To: North Liberty Planning Commission From: Dean Wheatley, Planning Director Subject: Site Plan Approval Request (Proposed Grant Elementary Addition)

This is a request from the Iowa City Community School District to approve an elementary school site plan for land located between CENTRO manufacturing and N Front Street. A Good Neighbor meeting was held on October 26 for the rezoning (which is now completed) and plat to allow any interested party an opportunity to comment on this rezoning prior to submission, and eight people attended. Most were interested in the site plan rather than the rezoning, so staff contacted those who signed in to let them know a site plan has been submitted and offered to review it with them. Bob and Mary Burns, as well as Jesse Burns, strongly advocated for the extension of North Bend Drive to not curve as shown on the preliminary site plan but to extend straight east to N Front Street. Chuck Deisbach of South Slope also had concerns related to difficulty they have entering and exiting the South Slope driveway, which is where City staff has directed the future alignment of North Bend Drive to terminate. Staff provided early guidance to the school district

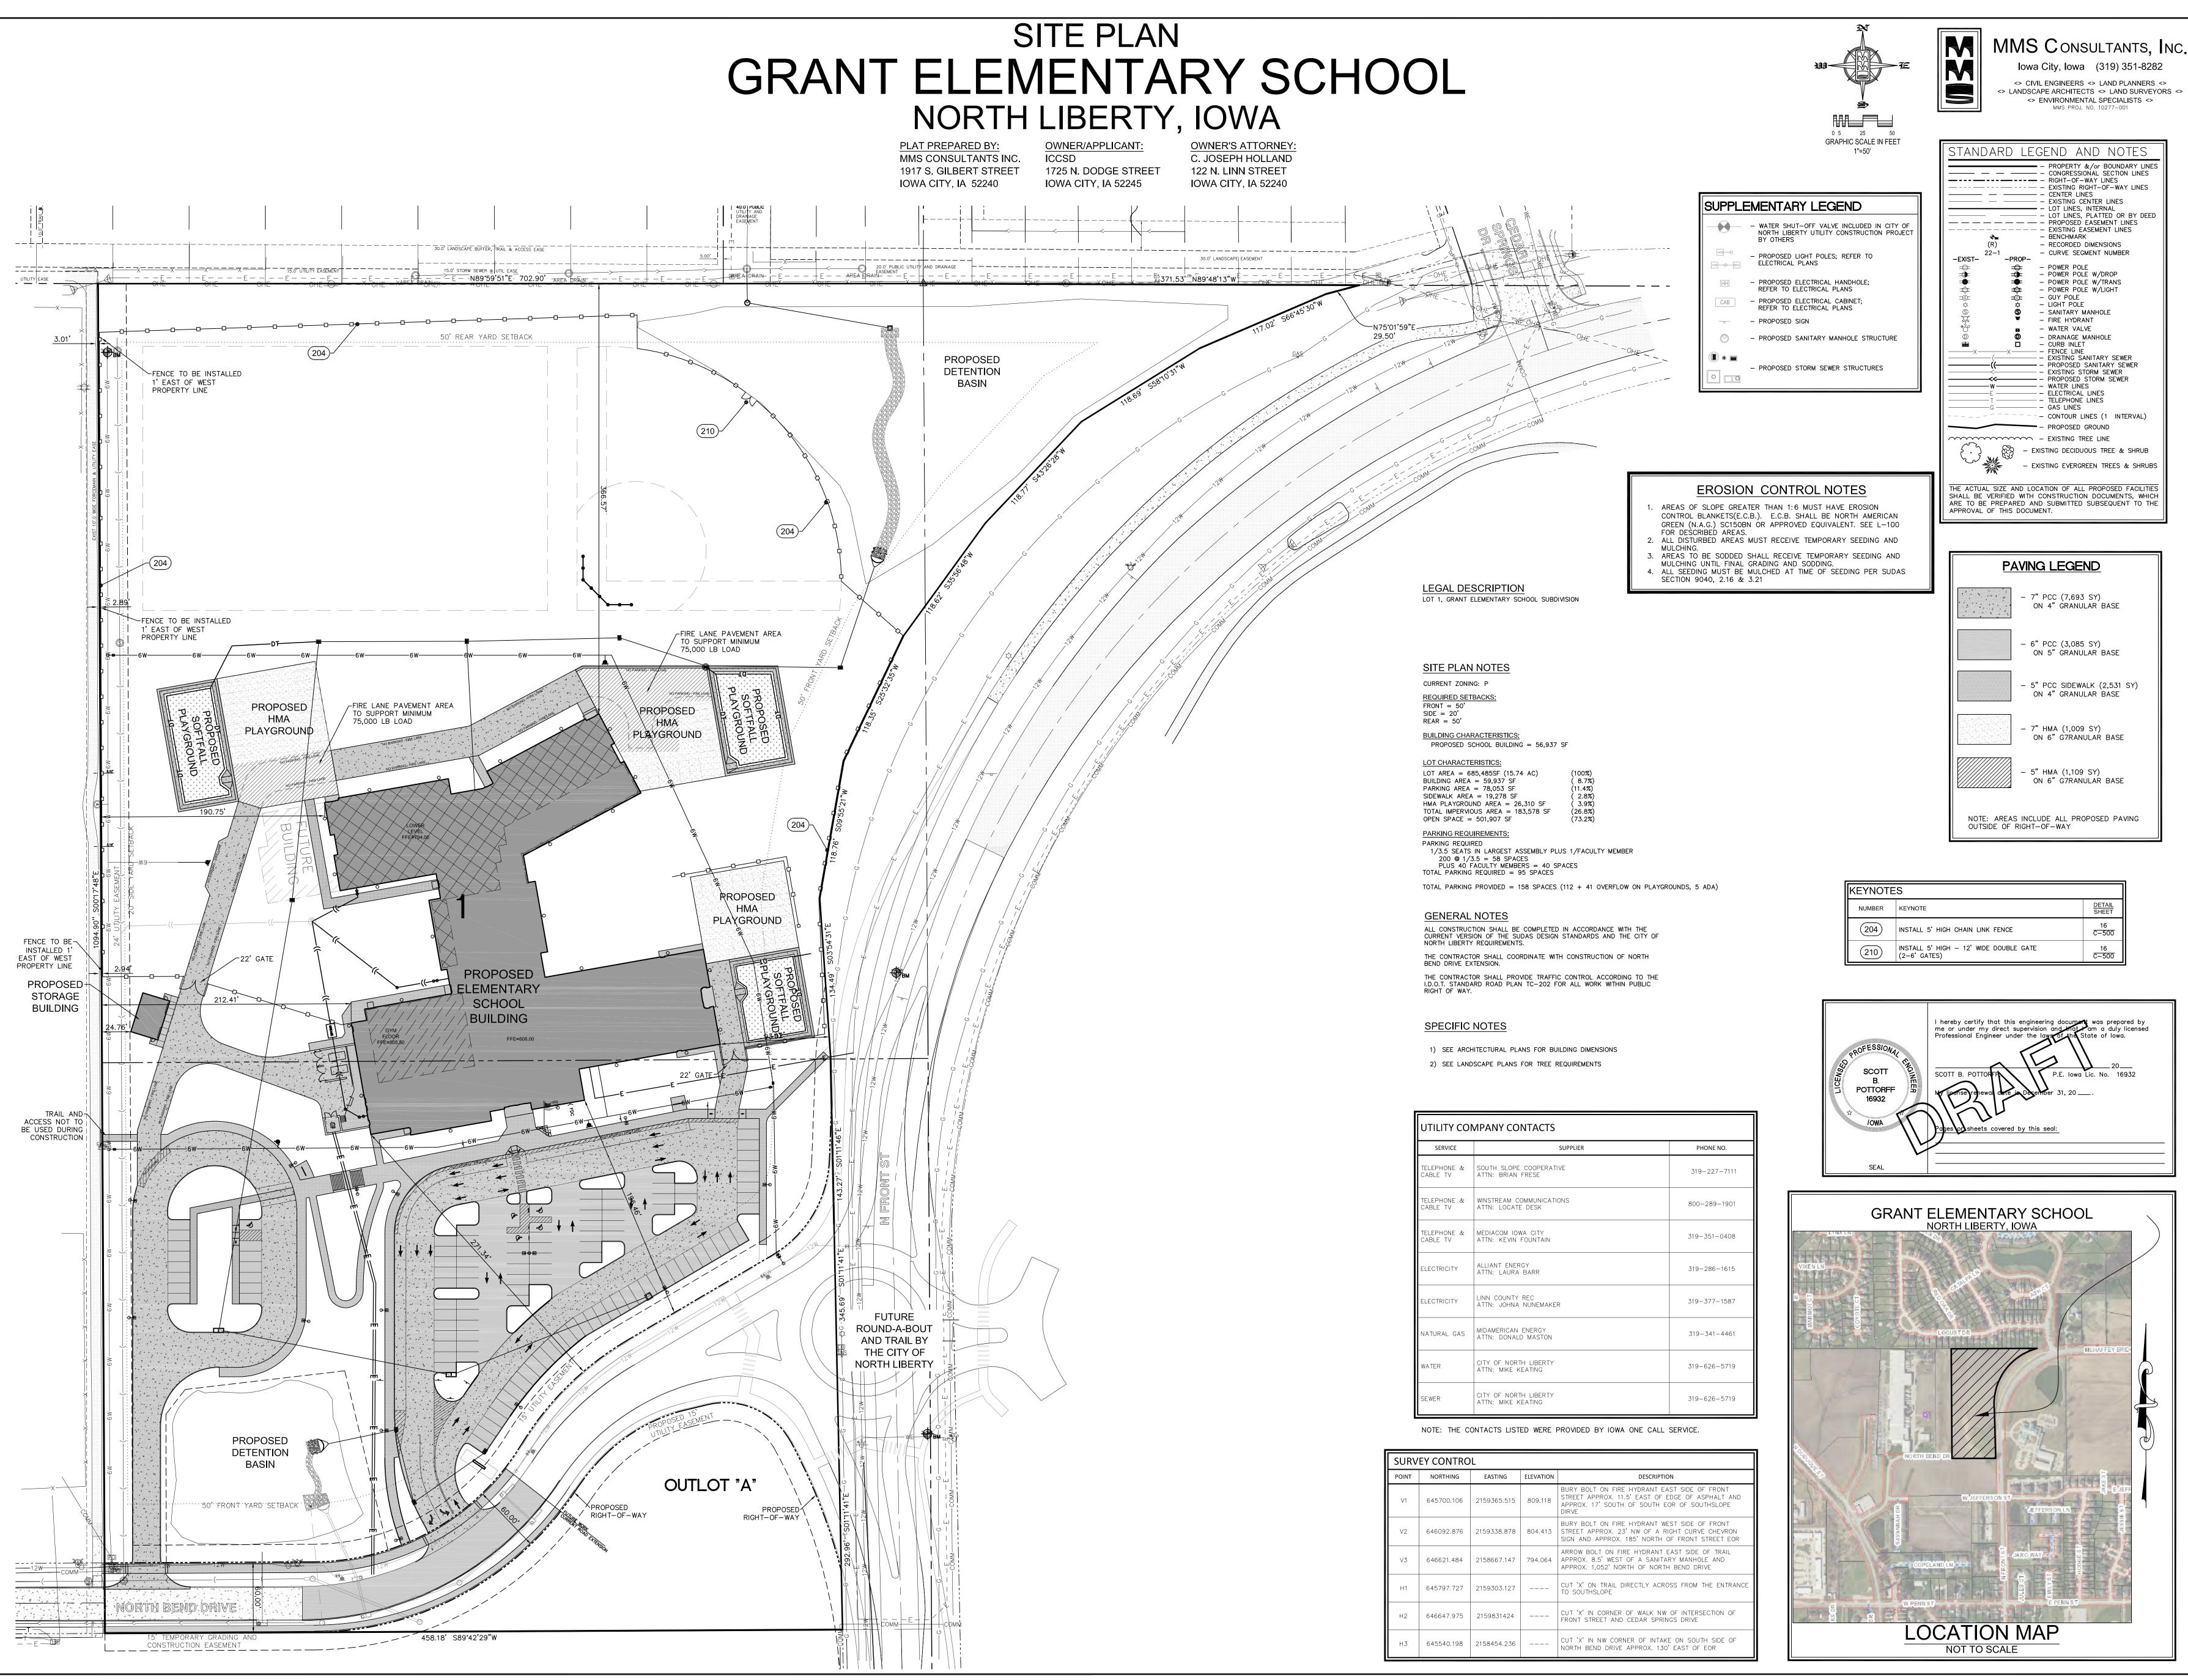
Staff recommends approval of the site plan. There are a number of notes for items that need to be taken care of as the overall City-School development process continues.

- The preliminary plat, final plat, and BMP Agreement will need to be developed and submitted together after site plan approval but before occupancy is permitted. The BMP (aka SMF) maintenance agreement is required between the Owner and the City for long term maintenance responsibilities of the stormwater management features. The owner is to provide proposed maintenance requirements to the City Engineer in Word format so that the City Attorney can fold them into the standard agreement format.

- A Site Plan Agreement between the district and the City establishing obligations for a number of issues related to the short schedule needed by the school district to start construction will be required prior to issuance of a building permit. Items to be included in the agreement include:

- Cost share for the proposed roundabout design and construction.
 - Schedule for completion of the preliminary plat, final plat, and BMP Agreement.
- Actual fire lane markings and signs will be determined by the fire department at a future time.

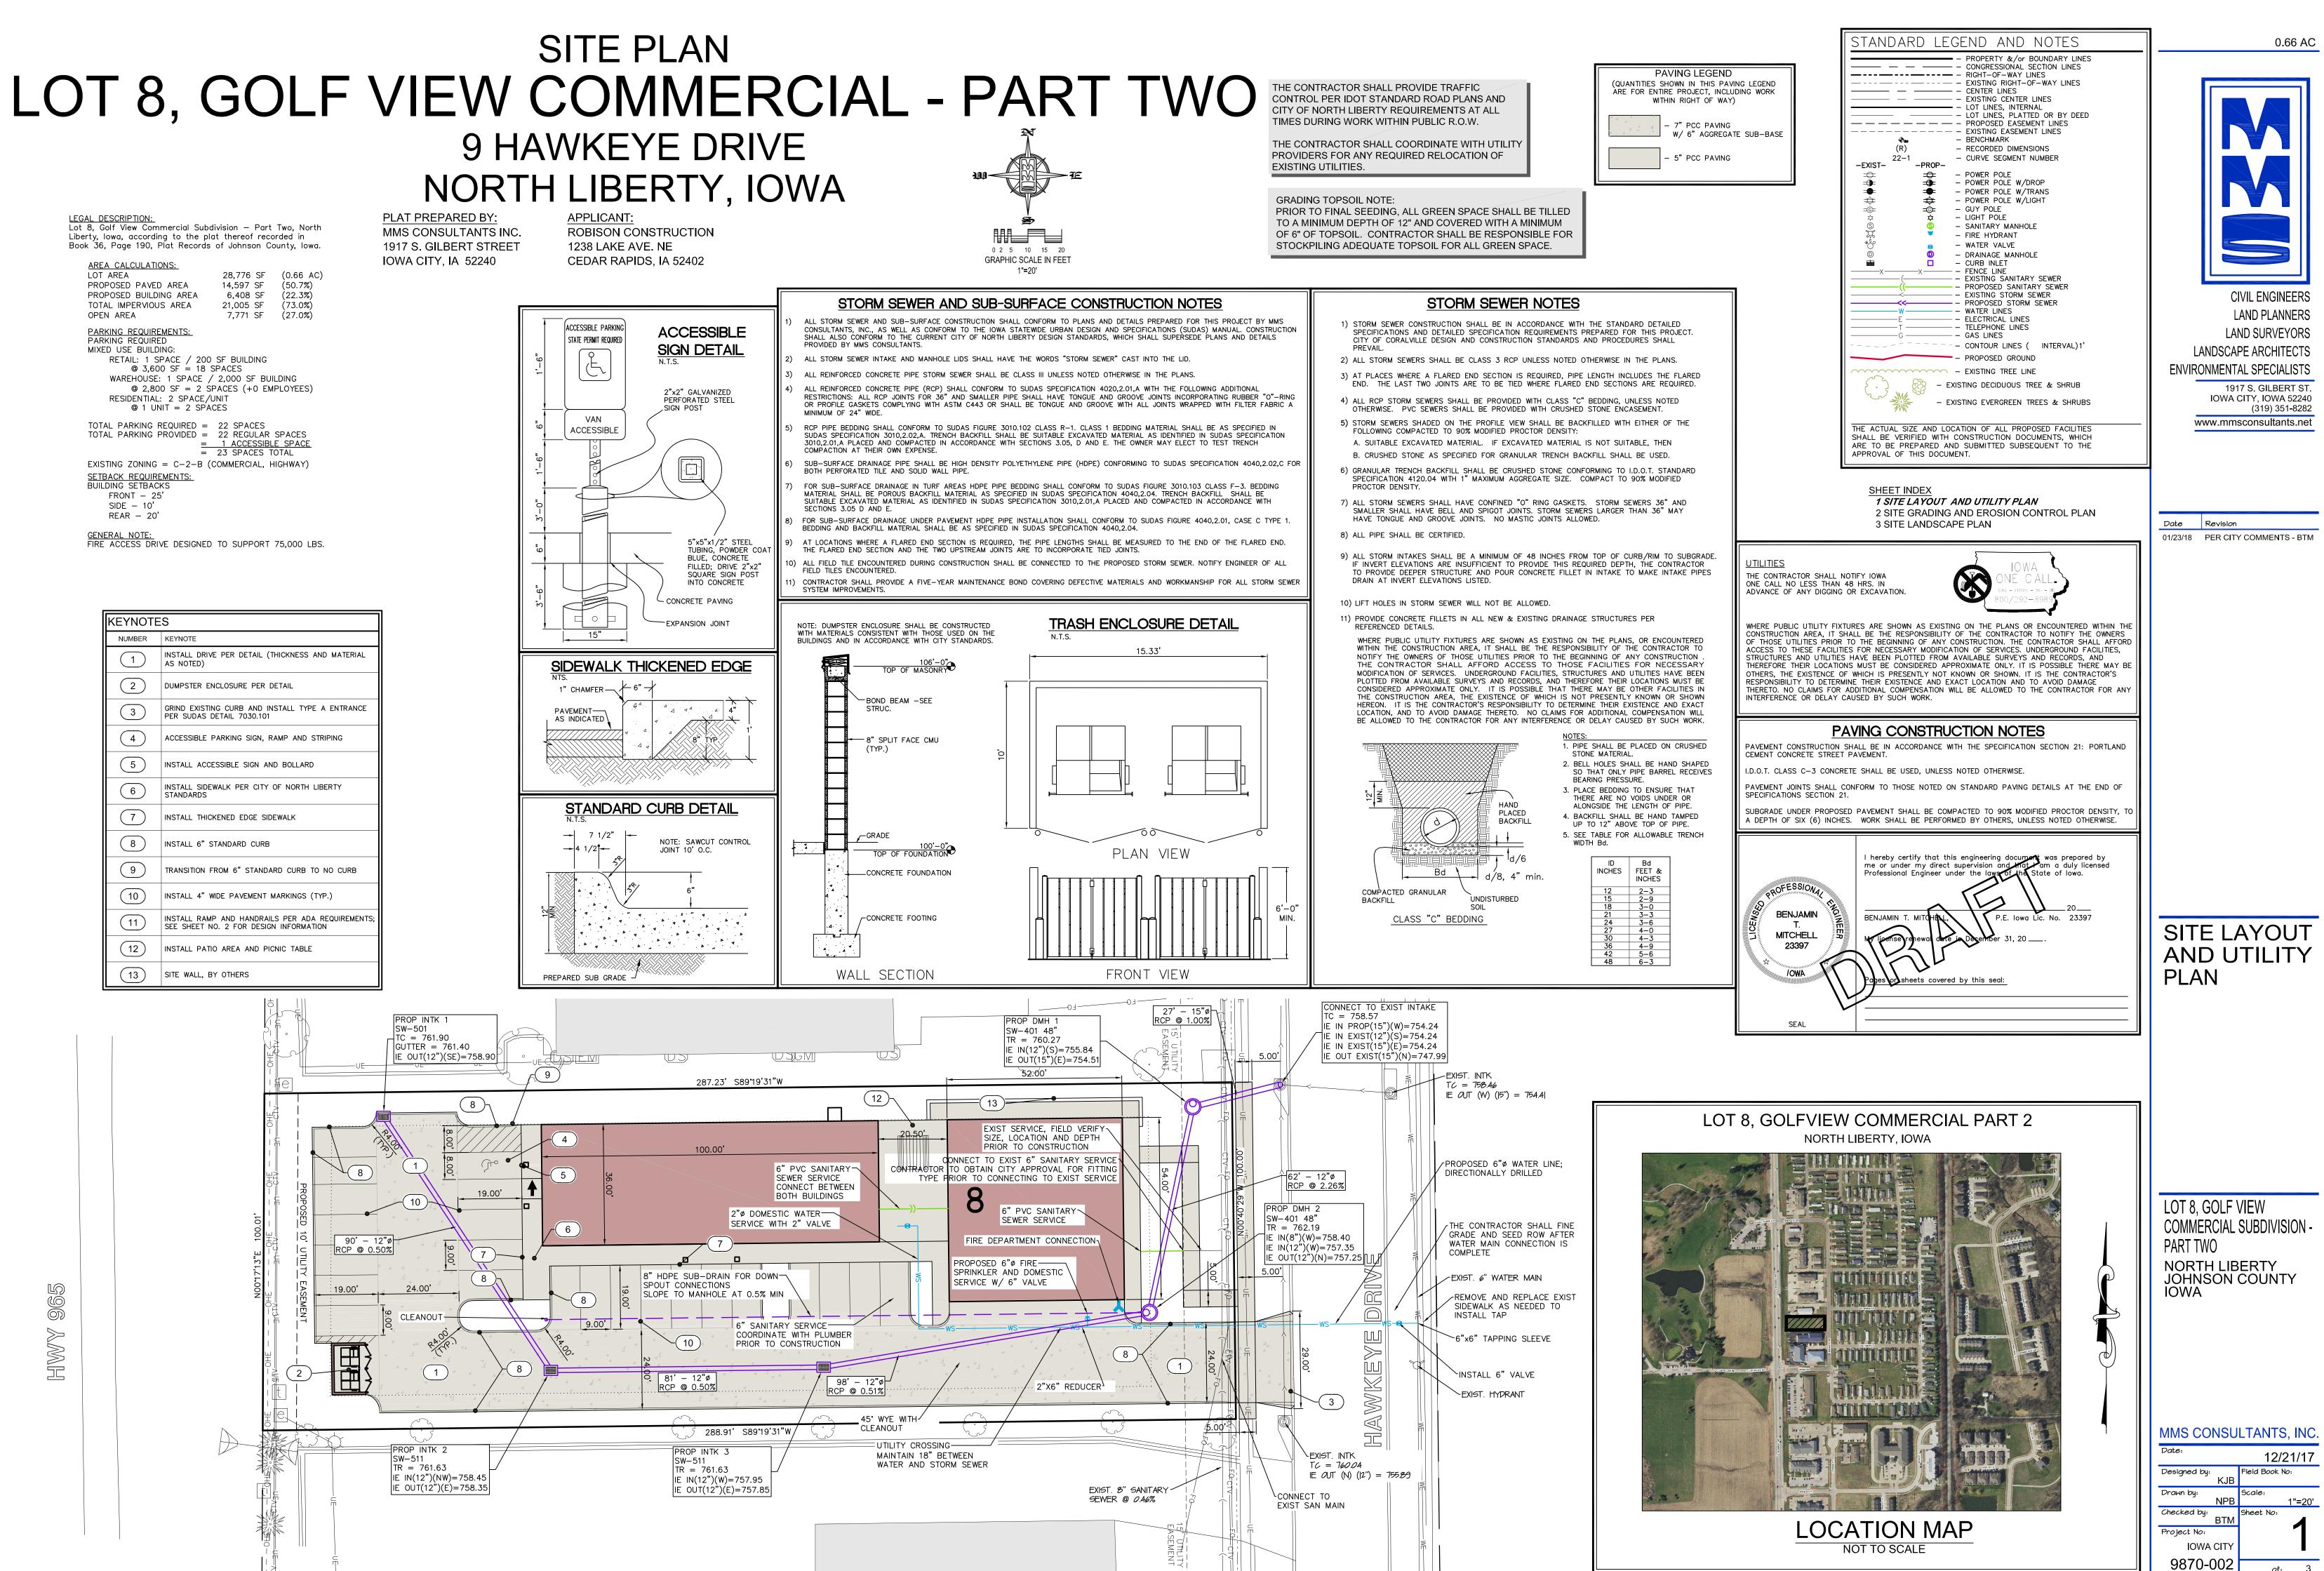
The site layout is similar to other buildings nearby and logical considering the shape of the lot, with buildings oriented east-west and parking near the 965 right-of-way. It should be noted that 965 is substantially higher in elevation than the lot under review. The site planning and landscaping plan meet basic requirements for development with a few exceptions noted below. There is no outside storage or display shown so none will be allowed unless specifically approved at a later time.

While the parking proposed meets the requirements as identified in the parking table on the site plan, any future uses will be extremely limited because of those numbers used, so as with other recent similar developments, an Owner's Acknowledgement of this issue and of possible occupancy certificate limitations is required prior to approval.

• Fire Department sprinkler connection for east building (Building #2) shall face Golfview Drive. FDC sprinkler connection location will be determined during fire sprinkler plan review.
